# CONVAIR

## COMMERCIAL CHANGE PROPOSAL

SPEC NO.: ZD-22-304

MODEL: 22-22 (Convair "880")

Enclosure: (A) One copy Page 3a - GENERAL ARRANGEMENT (Revised)

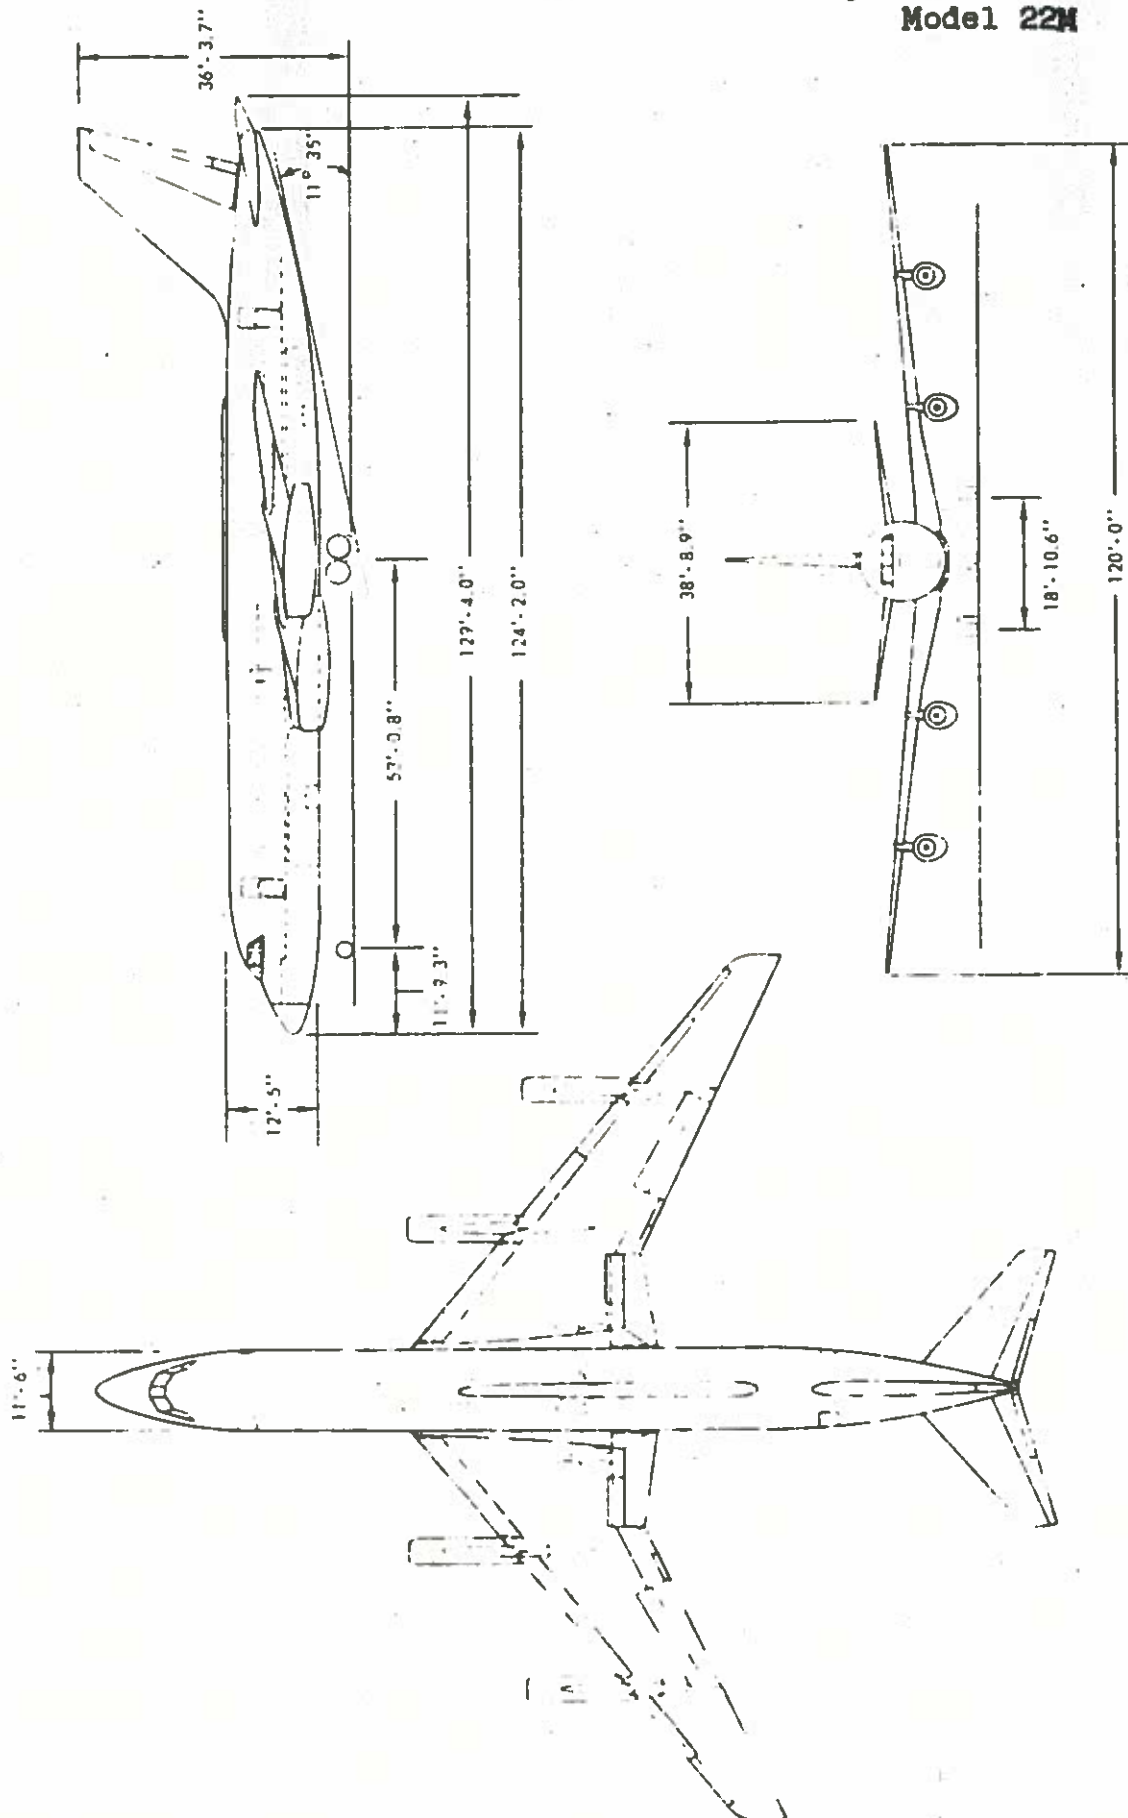
Replace above illustration in the specification with Enclosure (A) which shows Krueger Flap installation between inboard pylon and fuselage, and trailing edge inboard flap extension.

Enclosure: (B) One copy Page 49a - HYDRAULIC SYSTEM (Revised)

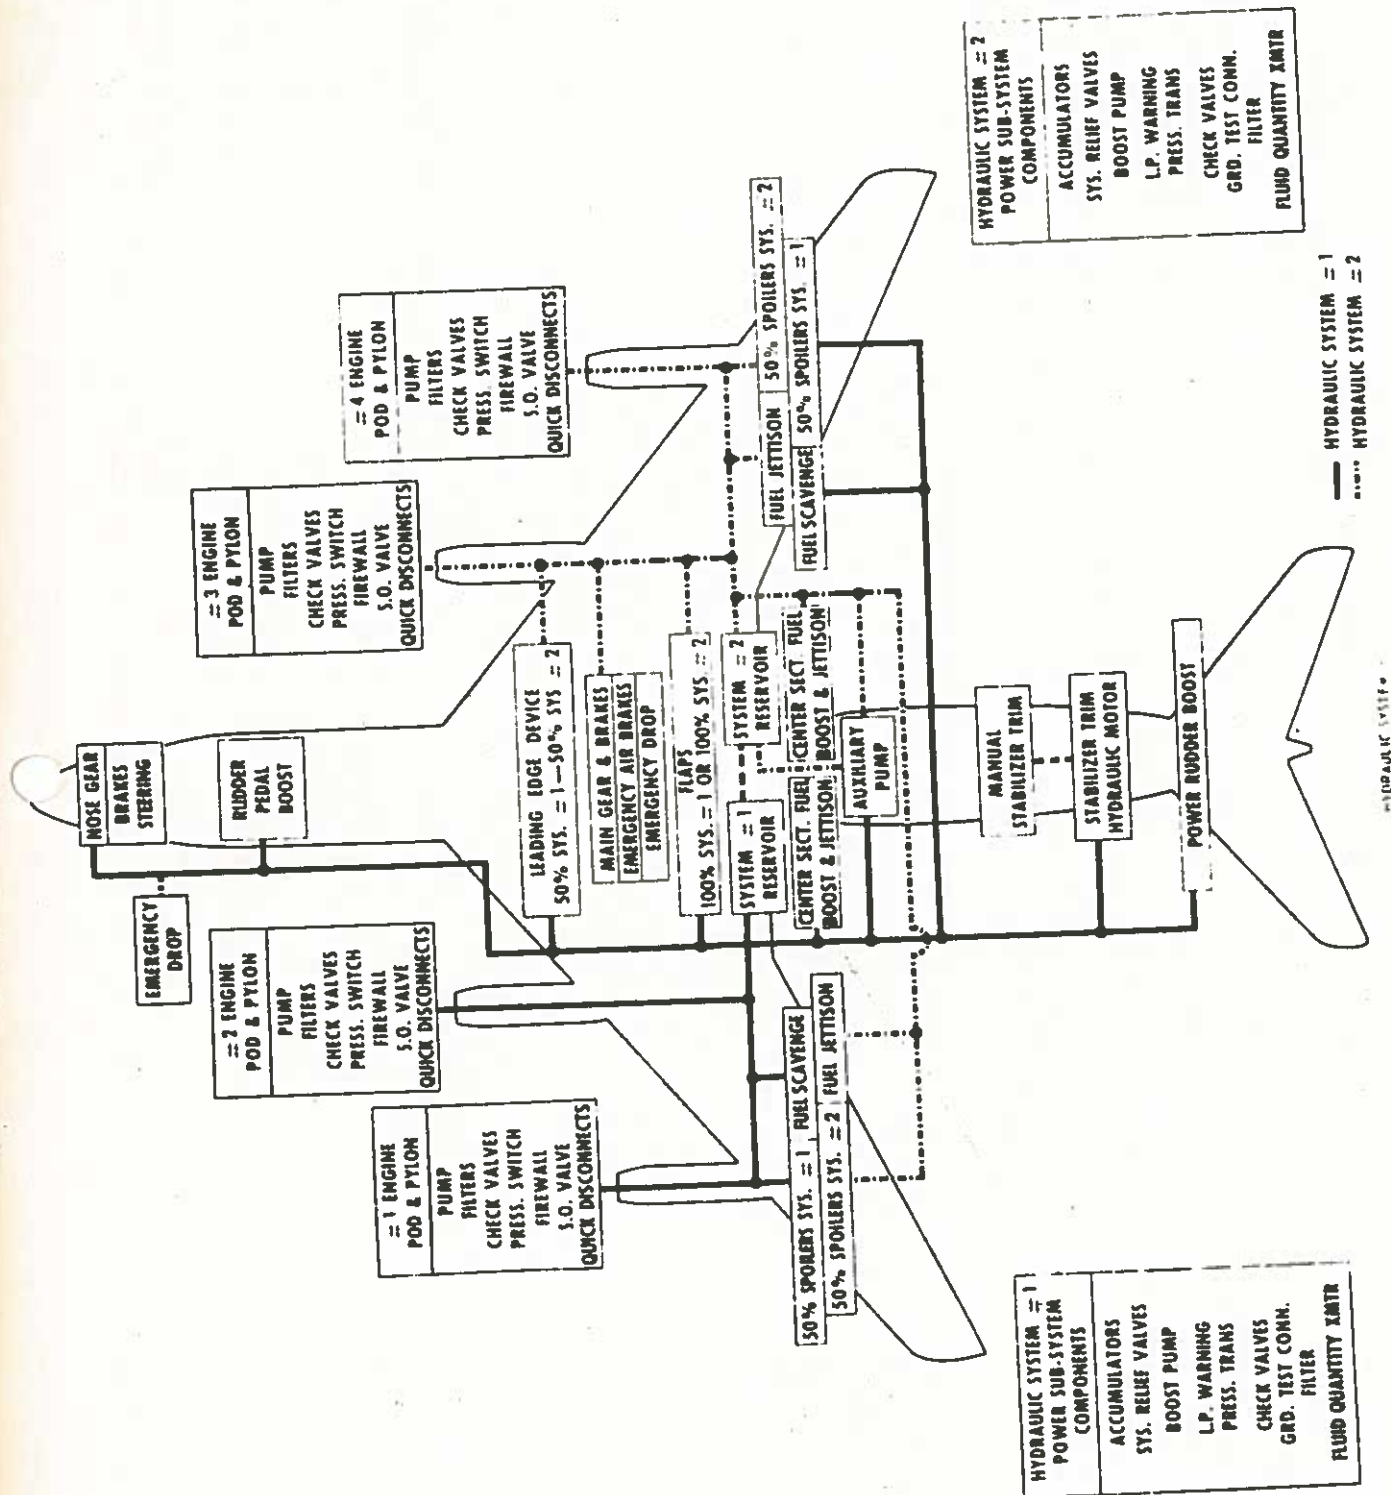
Page 49a, HYDRAULIC SYSTEM:

Replace above illustration in the specification with Enclosure (B) which shows 100 percent flap power available from either No. 1 or No. 2 Systems, rudder pedal boost, center section fuel boost and jettison, and deletes "TEMP. CONTROL" callout.

Page 7a, C. G. DESIGN LIMITS:

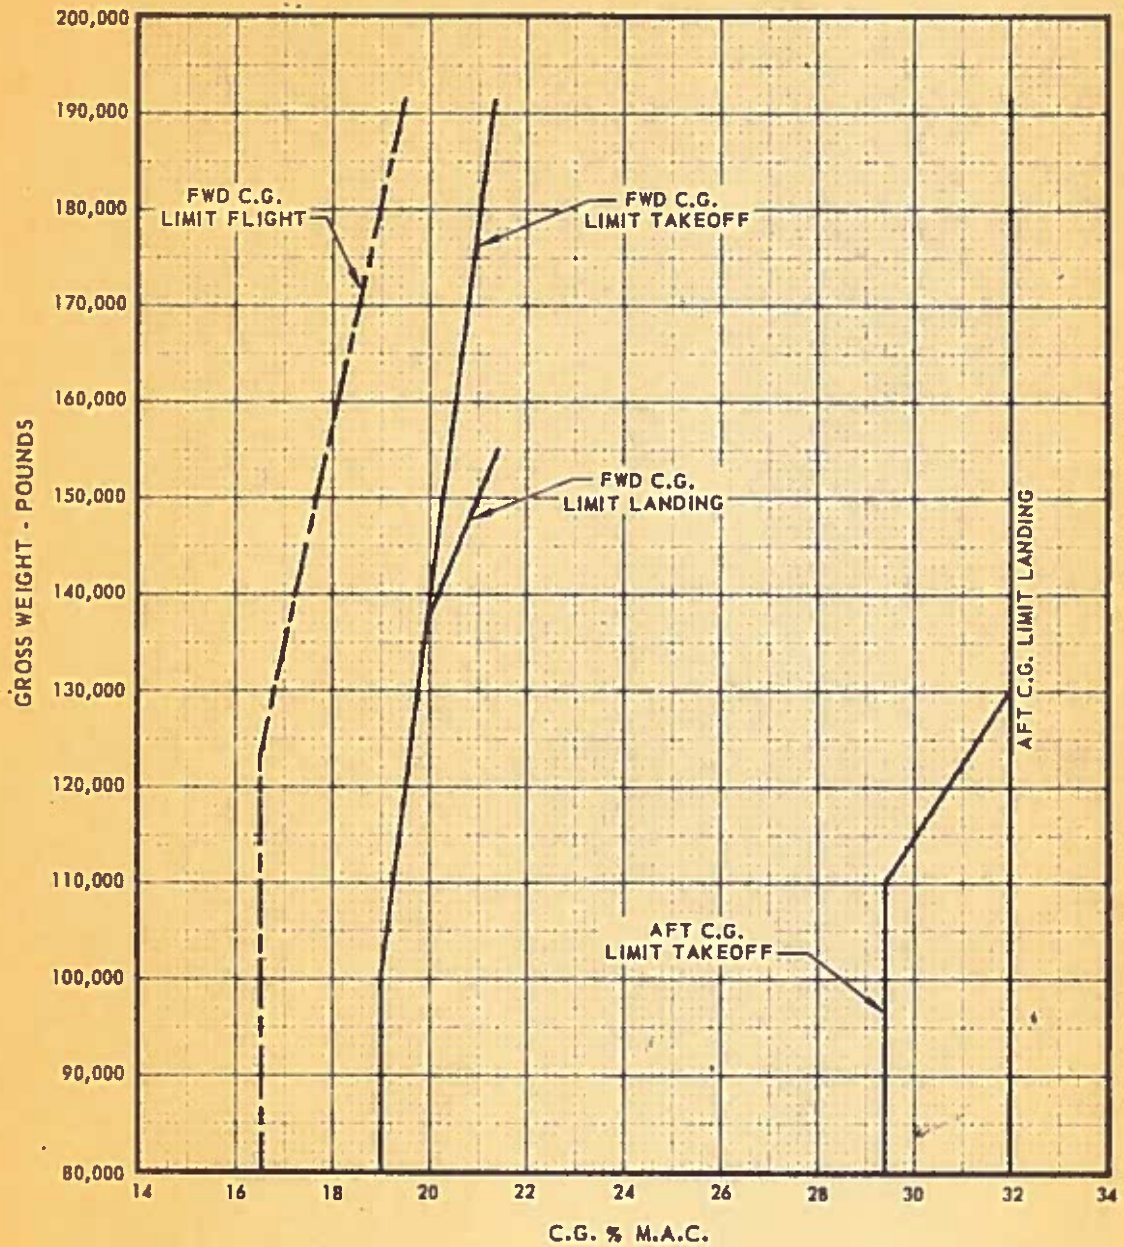
Replace above illustration in the specification with Enclosure (A) which adds new aft C. G. Limit takeoff and landing.

Enclosure: (A) One copy Page 7a, C. G. LIMITS (Revised)

Enclosure: (A) One copy of Page 99a - ESTIMATED CABIN PRESSURE SCHEDULE (Revised to show effects of the above change)

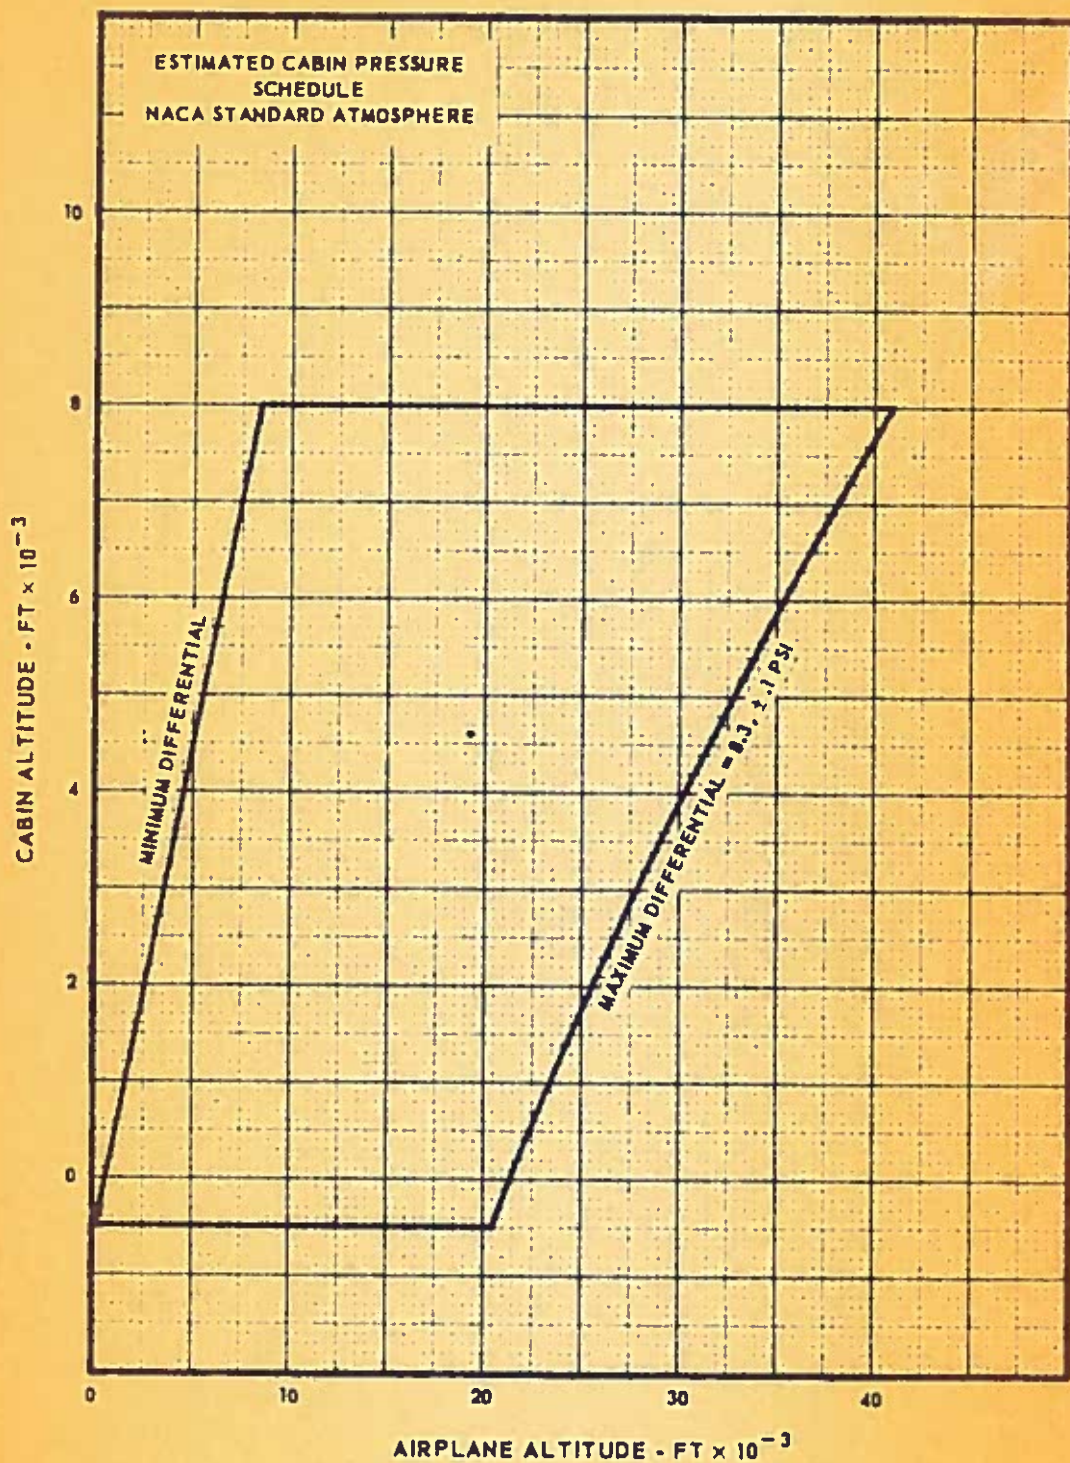
The above illustration will be revised to show effects of this change.
